Expert Opinion

North East Link Project (NELP) EES

| Date of Report: | 15 July 2019 |

Figure 8-1 to Figure 8-6 provide a visual comparison between the waterway and piped networks included within the modelling versus the Melbourne Water and Council stormwater systems at the same locations. These highlight the variation in drainage network definition between the different catchments.

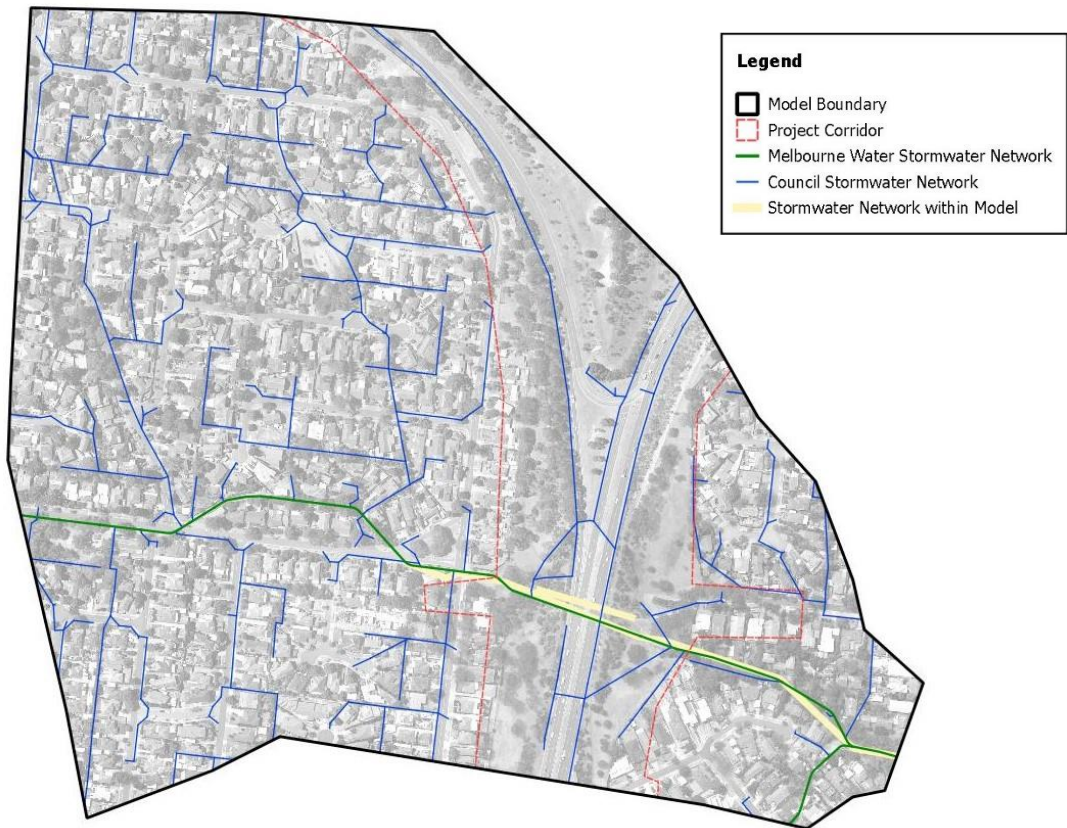
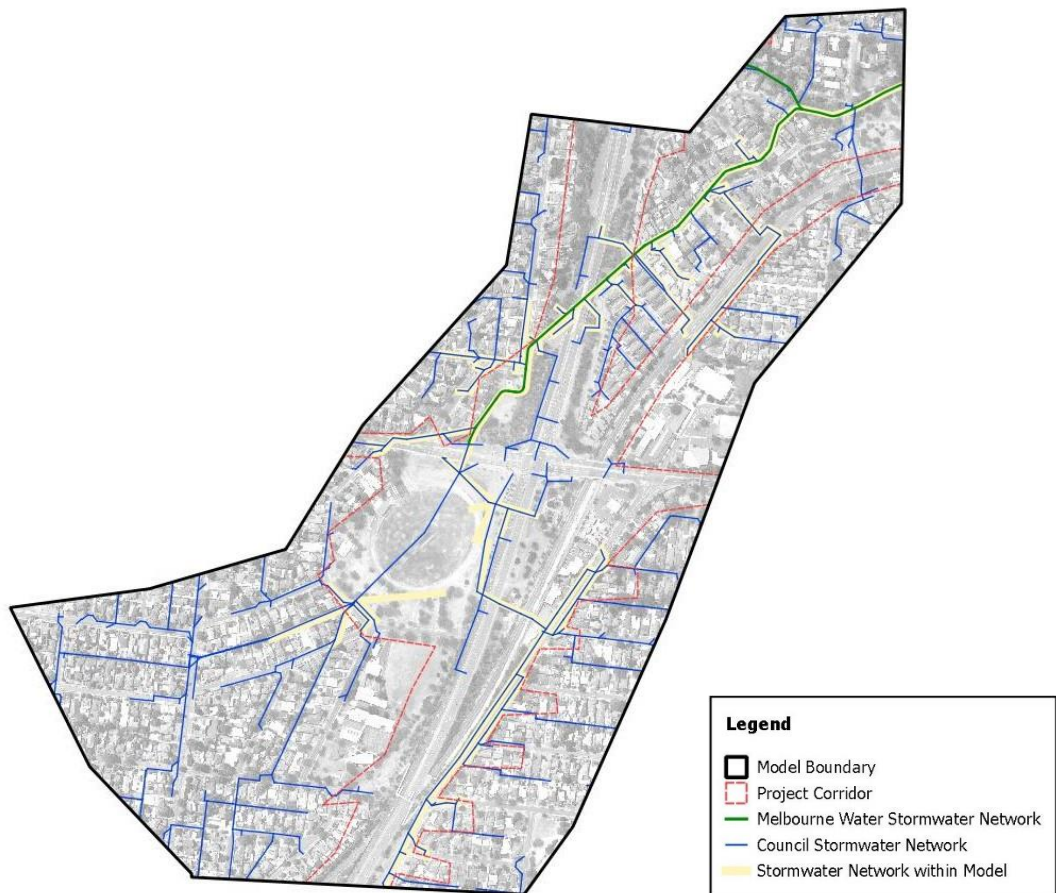
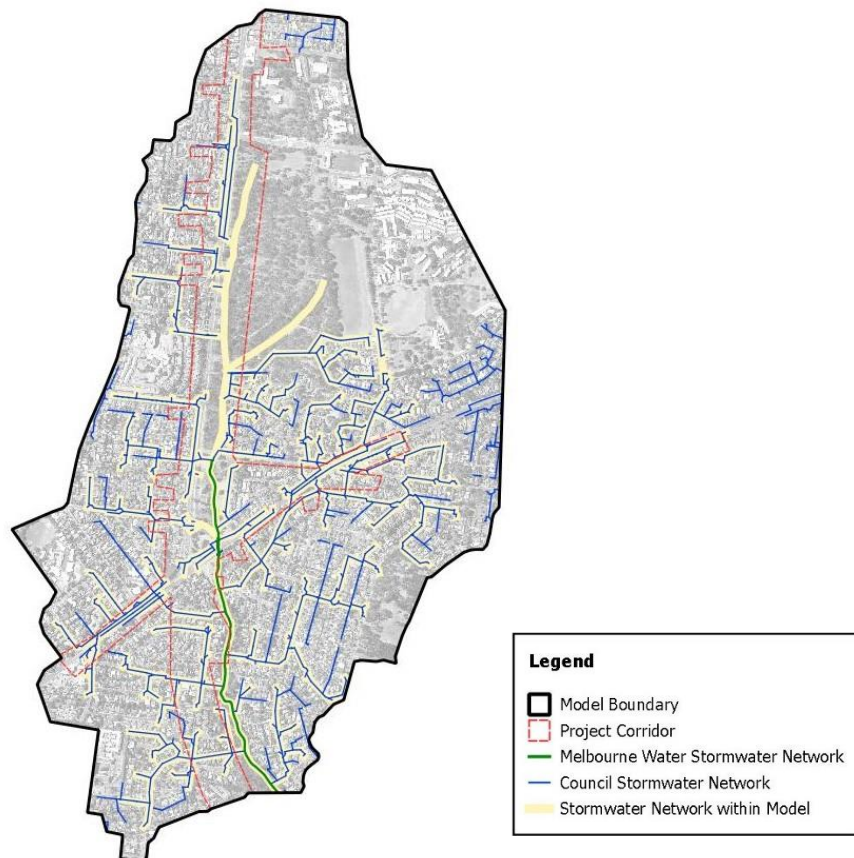
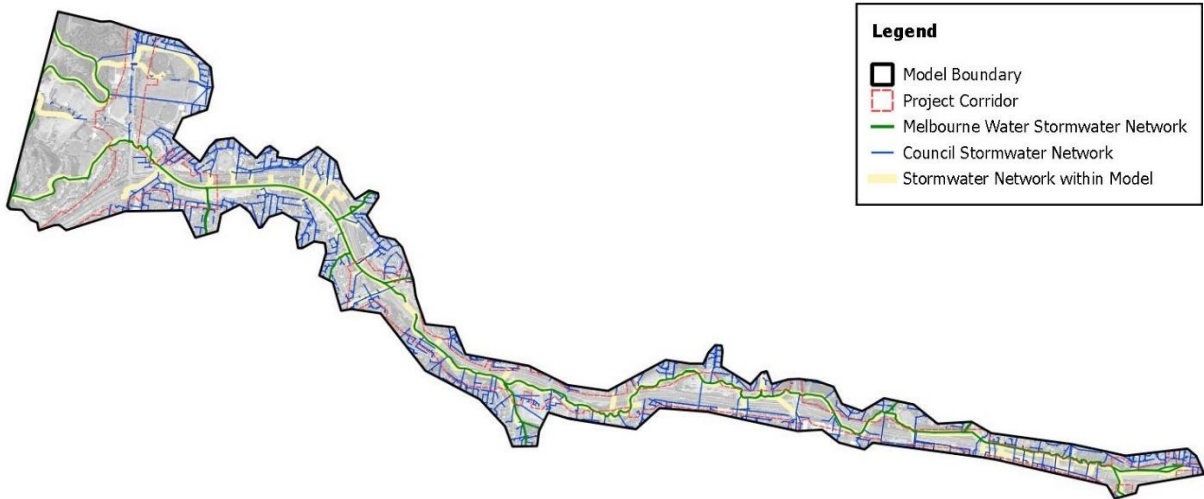
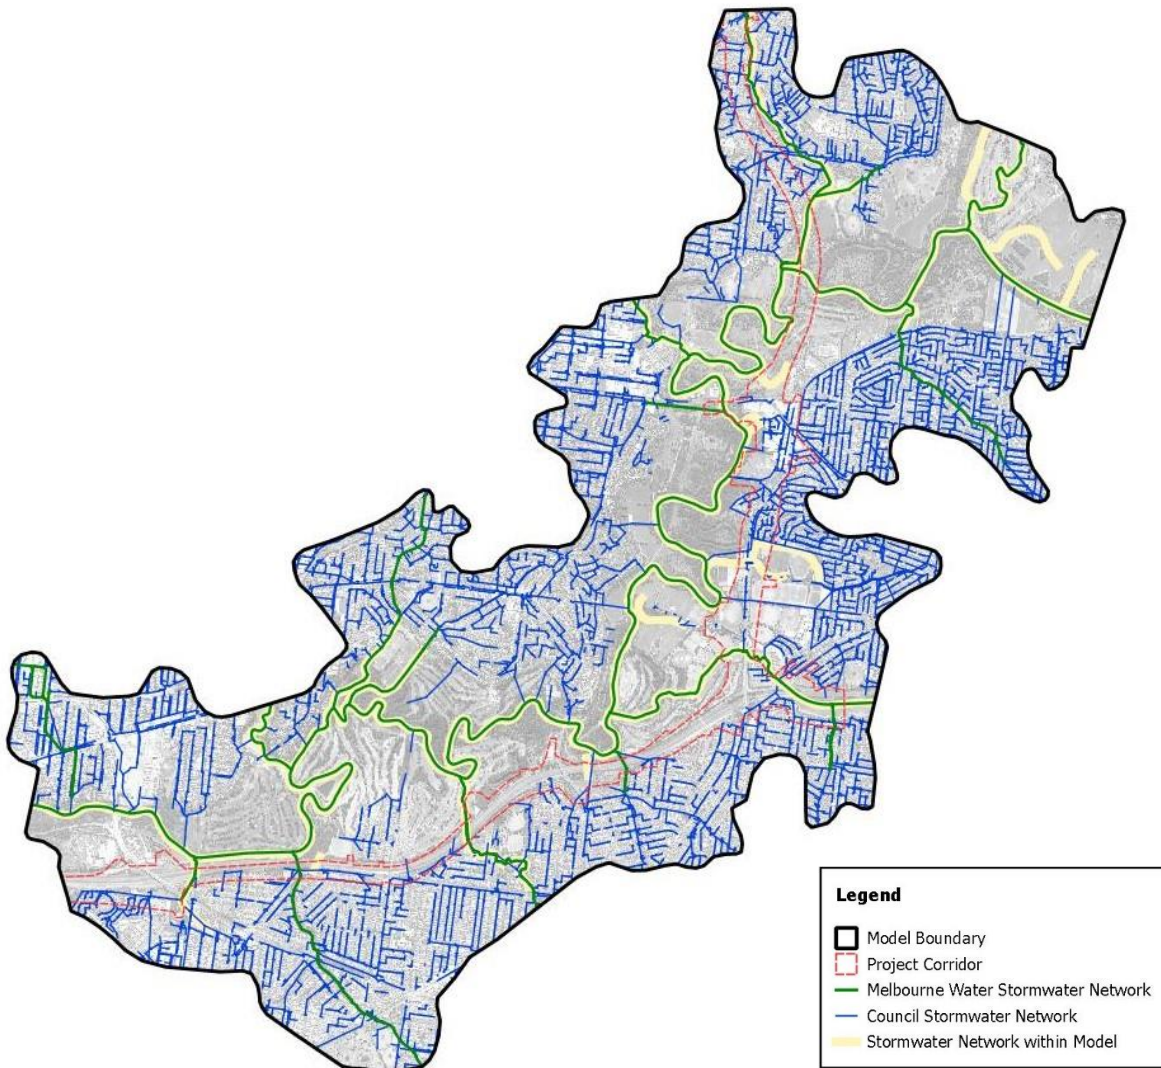
An example of this is the representation of both the Melbourne Water and Council stormwater systems within the modelling, some models contain quite refined networks whilst others only include a few key features to ensure flows are conveyed. Whilst a coarser approach to representing the stormwater network is most likely fit-for-purpose with respect to identifying impacts of the project within waterway corridors and on the Melbourne Water network, without a refined approach there is a possibility of not identifying smaller overland flowpaths and as such, identifying possible impacts. This potentially could result in impacts on the Council stormwater system being missed or under-represented.

Both the Banyule and Koonung Creek models appear to include a high level of detail with respect to the inclusion of the MW and Council stormwater networks, whilst Kempston and Yando Street Main Drain models do not exhibit the same level of detail. The Watsonia Station Drain model appears to contain reasonably detailed stormwater network and, whilst the Yarra River model does not include much of the minor network, due to the magnitude of flows being conveyed within the river, it is reasonable to assume this would have negligible impact on results.

Figure 8-7 Banyule Creek – Extract of Afflux Plot, source: EES Chapter 24 – Surface Water

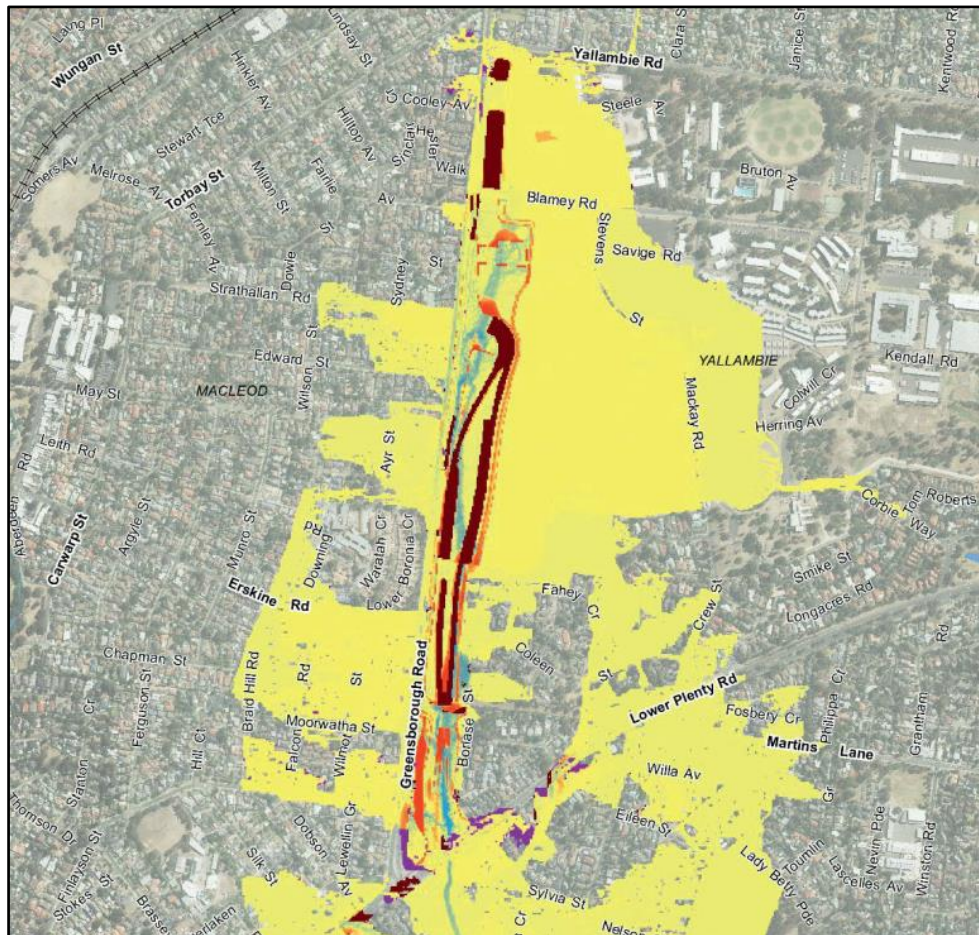
Figure 8-7 provides a snapshot of the afflux as a result of the project within the catchment, widespread albeit shallow increases in flood depth can be observed. There may be multiple viable solutions to this increase in flood risk however, no details are provided as to the potential mitigation measures nor are there any mitigation design results to reinforce the above statement.

Consequently, it is difficult to form an opinion as to the feasibility to mitigate the impacts on flood levels as a result of the project.
